## Qualification of ASE as an Additional Assembly and Test Site of SOT-223 Commercial Power Mosfets

# Product Change Notification

Product Group: Vishay Siliconix/July 22, 2013/PCN-SIL-0382013 Rev 0

## Appendix A: Tape and Reel Comparison

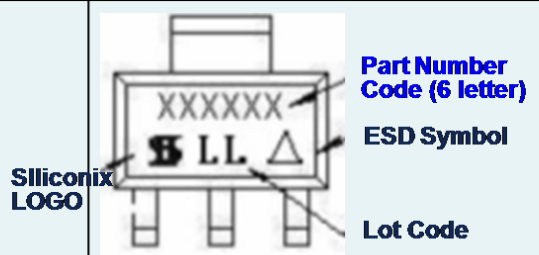
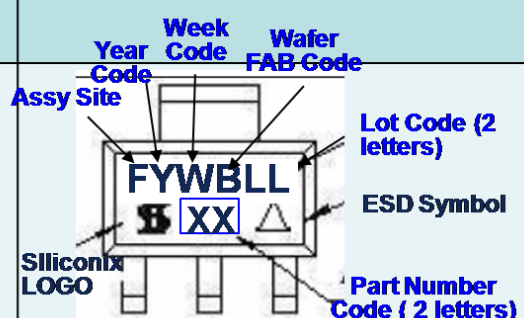
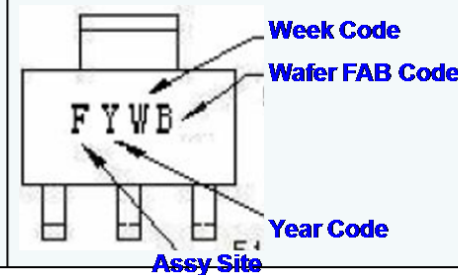
The dimensions of the Tape and the Reel supplied by ASE are slightly different than that provided by Carsem, our current sub-contractor for SOT-223 packages. A comparison with details can be found in Appendix A below.
